# Access Compliance Report

## Public Rights-of-Way (Curb Ramps)

Intersection ID: 10031811	Main Street: MILLENNIUM_AV	Cross Street: SAGE_PARK_DR	Location:	N
ADA ID: DB2080392622	Ramp Type: Directional1	Initial Pass/Fail: Fail	Overall Compliance: No	Severity Score: 1.25
Codes/Mitigation Info/Possible Solution		Field Measurements/Component Compliance

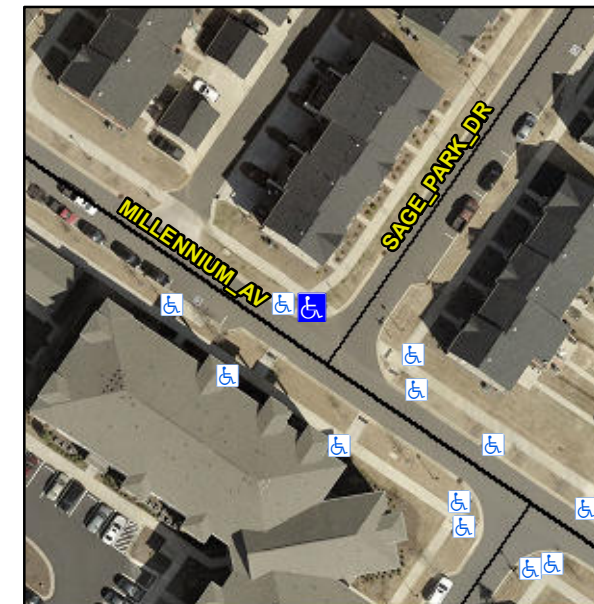
Compliance	Description	Data	Compliance	Description	Data
N/A	Ramp Length (in)	79.0	N/A	Grade Break?	N/A
Yes	Ramp Width (in)	69.0	N/A	Grade Break Slope (%)	0.0
Yes	Ramp Slope (%)	7.8	N/A	Grade Break XSlope (%)	0.0
No	Ramp XSlope (%)	3.1			
N/A	Flare Type LT	N/A	N/A	Flare Type RT	N/A
N/A	Flare Slope LT (%)	N/A	N/A	Flare Slope RT (%)	0.0
N/A	Flare Traversable LT?	N/A	N/A	Flare Traversable RT?	N/A
N/A	Landing Length (in)	0.0	N/A	DWS Provided?	N/A
N/A	Landing Width (in)	0.0	N/A	DWS Contrast?	N/A
N/A	Landing Slope (%)	0.0	N/A	DWS Length (in)	N/A
N/A	Landing X Slope (%)	0.0	N/A	DWS Full Width?	N/A
N/A	Landing Curb? (Y/N)	N/A	N/A	DWS Offset LT (in)	N/A
N/A	Shared Landing?	N/A	N/A	DWS Offset RT (in)	N/A
N/A	Gutter Ponding?	0.0	N/A	Gutter Slope (%)	N/A
N/A	Gutter Lip Ht (in)	0.0	N/A	Gutter X Slope (%)	N/A
N/A	Painted X Walk1?	No		Road Slope (%)	1.6
	X Walk 1 Direction	To SE		Road X Slope (%)	2.4
	X Walk 1 Width (in)	N/A		Clear Space?	N/A

X Walk 1 Slope (%)	1.6	N/A	Clear Space to XWalk (in)	N/A
	X Walk 1 X Slope (%)	2.4	N/A	Storm Grate/Utility Hazard?	N/A
N/A	Ramp inside XWalk1?	N/A		Storm Grate/Utility Type	
N/A	Any Obstructions?	N/A			N/A
	Obstruction Type		Yes	Surface Condition? (G/P)	Good
			N/A	Curb Slope (%)	15.4

**Remove & Replace Entire Ramp.**

**R304.5.3**
